MONTGOMERY COUNTY HISTORIC PRESERVATION COMMISSION
STAFF REPORT

Address:	3804 Bradley Ln., Chevy Chase	Meeting Date:	9/9/2020
Resource:	Contributing Resource Chevy Chase Village Historic District	Report Date:	9/2/2020
Applicant:	Rohit Rao (Anthony Colella, Agent)	Public Notice:	8/26/2020
Review:	HAWP	Tax Credit:	No
Case Number:	35/13-20Z	Staff:	Michael Kyne
PROPOSAL: New fence and retaining wall

LSK-30 FENCE EXTENSION WEST SIDE

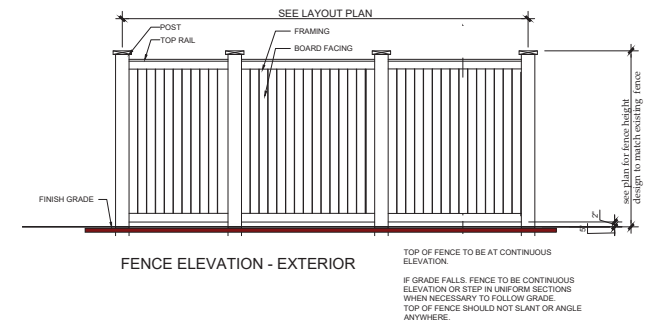
- Extend an existing solid board fence at the west (right, as viewed from the front) property line.
 - The fence will be extended 25'-3 1/16" toward the front of the property.
 - The fence extension will be a minimum of 5' high and a maximum of 6' high, depending on grade.
- Replace in-kind and extend an existing timber retaining wall at the east (left) property line.
 - The retaining wall will be extended toward the rear.
 - The retaining wall will have a maximum height of 20"

Although the proposed fence will be greater than 4' high forward of the rear plane of the historic house, the house has a moderate setback from the street, and the fence is entirely at the side property line. Therefore, staff finds that the fence will not detract from the open streetscape, and, in accordance with the *Guidelines*, should be reviewed with moderate scrutiny. Applying moderate scrutiny, staff finds the fence compatible with the subject property and surrounding historic district.
